California Traffic Control Devices Committee Agenda Item Report

| Item Number: 22-07 | |
| Description: Proposal to add new word message sign to California Manual on Uniform Traffic Control Devices (CA MUTCD) Section 2I.09 to report the presence of pedestrians on highways by calling 911 to improve roadway safety. | |

Attachment B – Proposed Revisions to Figure 2I-8(CA).

Figure 2I-8 (CA). Radio, Telephone, and Carpool Information Signs

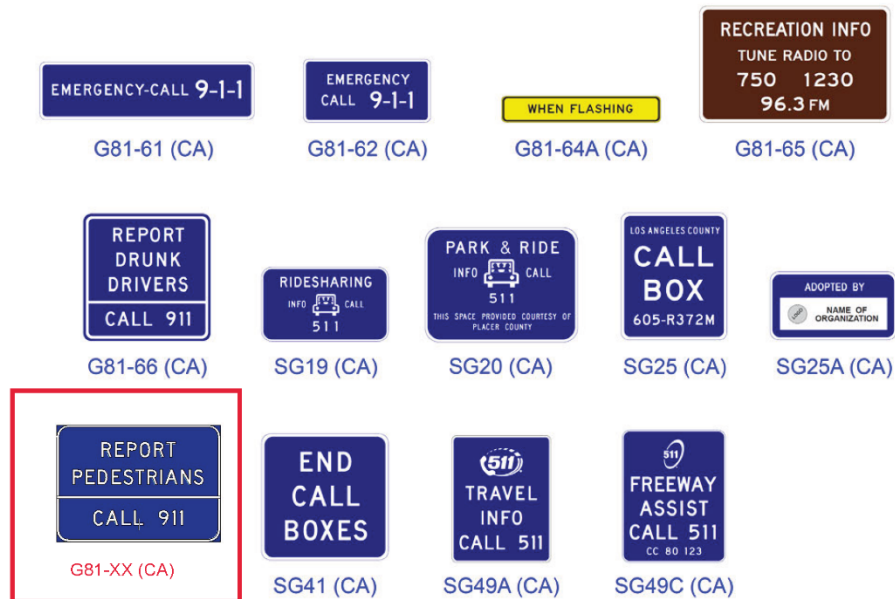
The proposed sign is similar to the REPORT DRUNK DRIVERS CALL 911 (G81-66(CA)) Sign. Installation of the proposed sign potentially will encourage road users to report the presence of pedestrians to CHP by calling 911.
